Agenda Item # 1 - HOLDOVER

SUB-002810-2024

Butler – Esau Subdivision

APPLICATION NUMBER 1 DATE March 21, 2024

DETAIL SITE PLAN

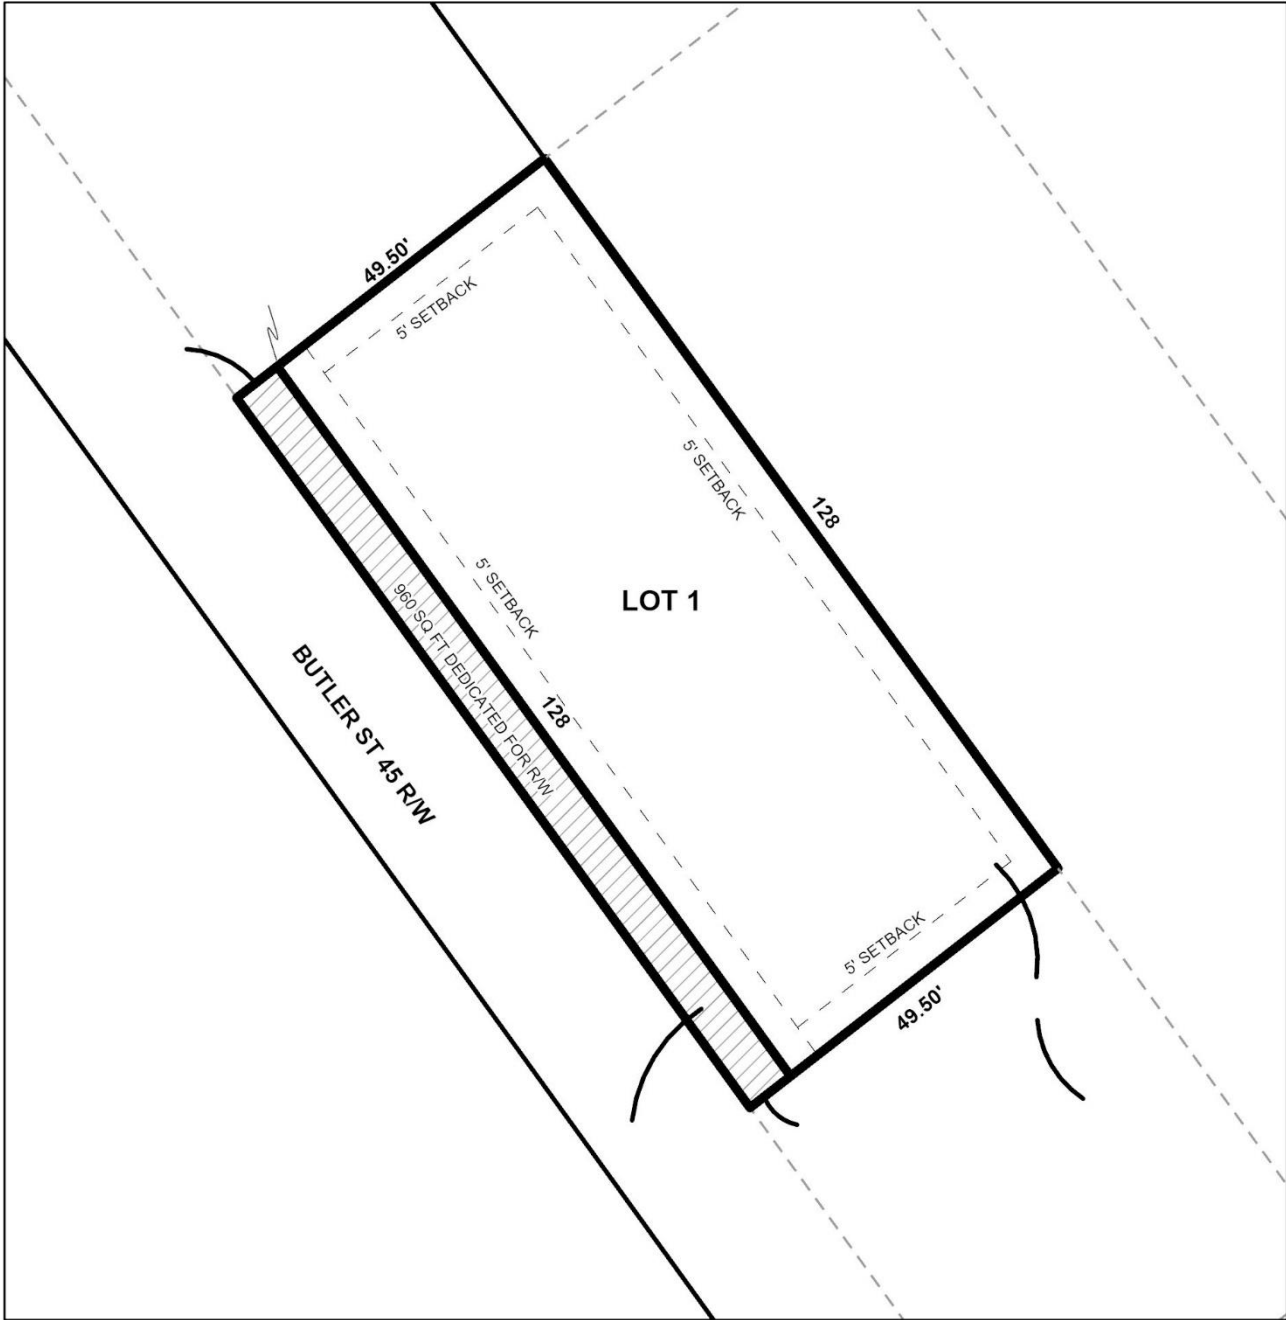
To address the issues above, a revised plat was submitted that eliminated the parcel at the corner of Butler Street and Esau Avenue. The revised plat illustrates the needed dedication along Butler Street (# 2) and the illustration of a compliant front yard setback (#4).

Regarding item #1, the revised plat does NOT address the number of dwellings on Lot 1. Item #2 required the dedication of a radius at the intersection of Butler Street and Esau Avenue and Item #5 required the illustration of the lot sizes in square feet and acres after any required dedication. As stated, the revised plat simply eliminated the metes and bounds parcel at the corner of Esau Avenue and Butler Street. The current owner of the omitted parcel at the corner of Esau Avenue and Butler Streets deeded off proposed Lot 1 in 1991, without subdivision approval; consequently, neither the proposed lot nor the omitted parcel is a legal lot of record as required by Section E.1. of the Subdivision Regulations.

The minimum lot size is 6,000 square feet for a site located in a R-1, Single-Family Urban District. While the proposed Lot 1 would be 6,336 square feet (after dedication) and would thus be compliant, the "remainder" of the lot at the corner would be 4,104 square feet (without dedication) and thus woefully substandard.

While dedication has been provided, further research indicates that while Butler Street is not constructed to city standards; ie, without curb and gutters, there is a sidewalk along one side of Butler Street. If dedication is not required, the overall site (including the "omitted portion" at the corner) would consist of 11,400 square feet, and if then equally divided, both lots would be roughly 5,700 square feet (when accounting for the dedication of the radius). Two slightly substandard lots would seem to be more in keeping with the surrounding development than having one compliant lot, and the other lot much smaller than all the surrounding lots.

The site is within an Urban sub-district, which allows five-foot (5') front yard setbacks. The five-foot (5') minimum building setback line is only indicated for proposed Lot 1 along Butler Street. No minimum building setbacks are indicated for proposed Lot 2 along either street frontage.

table furnishing the same information should be provided on the Final Plat. However, proposed Lot 1 currently has two (2) dwellings on it, in violation of Article 2, Section 64-2-5.E. of the UDC, and as such, cannot be approved.

Proposed Lot 2 is currently vacant, but does not meet the minimum 6,000 square-foot size requirement of Article 2, Section 64-2-5.E. of the UDC for lots in an R-1, Single-Family Residential Urban district, as it is labeled to be 4,100.97 square feet. It appears from a review of Probate Court records that the parcel was created after 1962, thus it cannot be considered to have been legally created.

1. Revision of the plat to illustrate two (2) equally sized lots of approximately 5,700 square feet each,
2. Removal of at least one (1) of the dwellings from the proposed lot,
3. Revision of the plat to illustrate the dedication of a 25-foot radius curve at the intersection Butler Street and Esau Avenue;

4. The illustration of the required five (5) foot minimum building setback line along both street frontages (as measured from radius dedication); and
5. Revision of the plat to label both lots with their size in both square feet and acres after any required dedication.
